SUBJECT: COOPER NUCLEAR STATION - AMENDMENT NO. 150 TO FACILITY  
OPERATING LICENSE NO. DPR-46 (TAC NO. 81148)

SUBJECT: COOPER NUCLEAR STATION - AMENDMENT NO. 150 TO FACILITY  
OPERATING LICENSE NO. DPR-46 (TAC NO. 81148)

RELATED TO AMENDMENT NO. 150 TO FACILITY OPERATING LICENSE NO. DPR-46

FIGURE 2.1.1  
REACTOR WATER LEVEL  
INDICATION CORRELATION

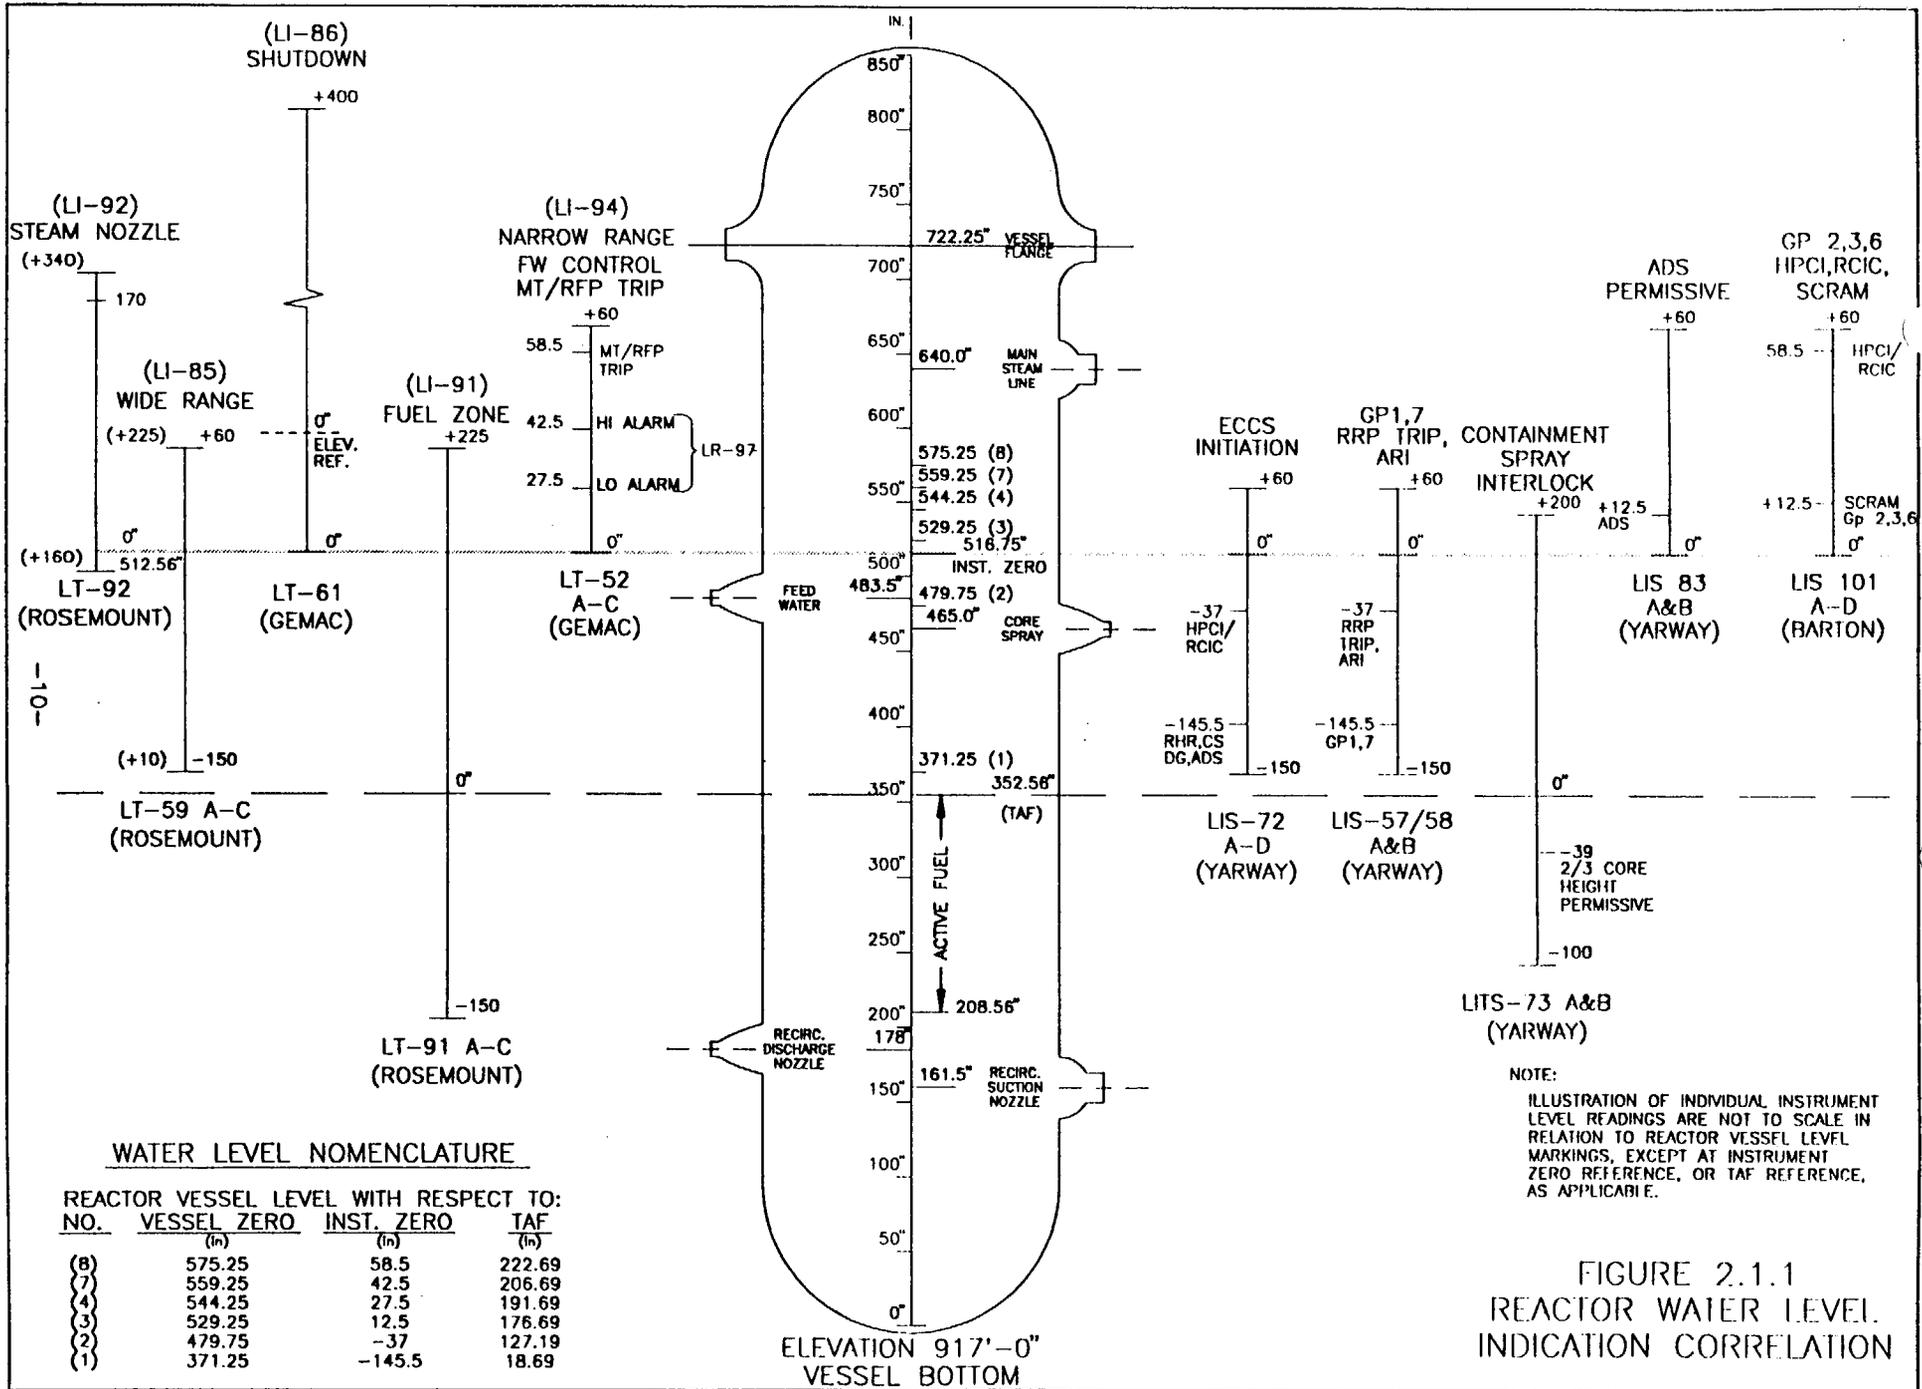
The amendment changes the Technical Specifications to revise the appearance of Figure 2.1.1, Reactor Water Level Indication Correlation. In addition, changes will be made to Paragraph 4.7.C. of the Bases and to Paragraph 6.1.6, ADMINISTRATIVE CONTROLS/ORGANIZATION Responsibility.

- 1) provide a new format for Figure 2.1.1, Reactor Water Level Indication Correlation;
- 2) delete the third sentence of Paragraph 4.7.C of the Bases addressing the performance of tests to demonstrate secondary containment capacity prior to the time primary containment is opened for refueling; and
- 3) amend the second sentence of Paragraph 6.1.1, ADMINISTRATIVE CONTROLS/ ORGANIZATION Responsibility, to designate the Senior Manager of Staff Support as an additional alternate to assume responsibility in the absence of the Division Manager of Nuclear Operations.

The first of these changes involves a modification of the format for the Reactor Vessel Level Indication Correlation figure. This change is administrative in nature. It does not involve any changes in numerical vessel level setpoint values and their associated instrumentation, which are controlled elsewhere in the CNS Technical Specification. The proposed change would present the figure in a manner that would more accurately illustrate level transmitter and level indication identification nomenclature numbers.
